Rezoning Transportation Analysis

Petition Number: 2020-103

General Location Identifier: 21337101

Date	Description
08-23-2020	First Review
09-29-2020	Second Review
10-26-2020	Third Review
01-19-2021	Fourth Review

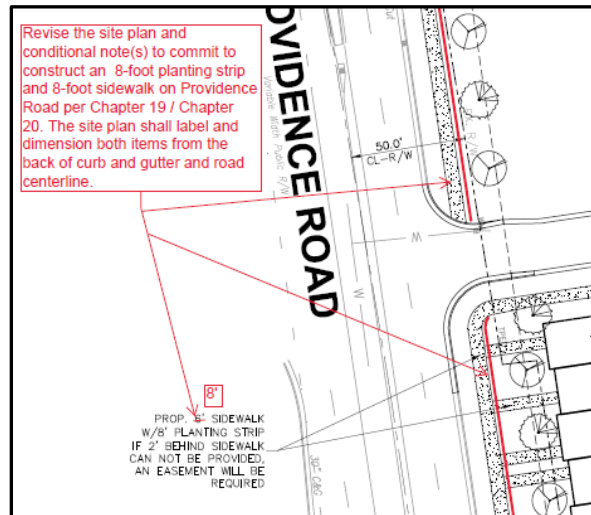
9. **RESOLVED: Revised Comment per revised site plan (10/26/2020):** The petition is requesting an Urban Residential — 2 (UR-2) Zoning District, which provides regulations on public and private street design for conditional plans. The petitioner shall revise the Alexander Road site plan to

~~realign and redesign private street access to a one-way ingress only (refer to the CDOT LD checklist for City design requirements). Feasibility of a raised median on Alexander Road shall be considered. Petitioner will provide the LSD for the driveway on Alexander Road and the intersection of Providence Road and Alexander Road, both horizontal and vertical included to show distance meets CDOT's Sight Distance Policy and AASHTO's A Policy of Geometric Design of Highways and Streets.~~
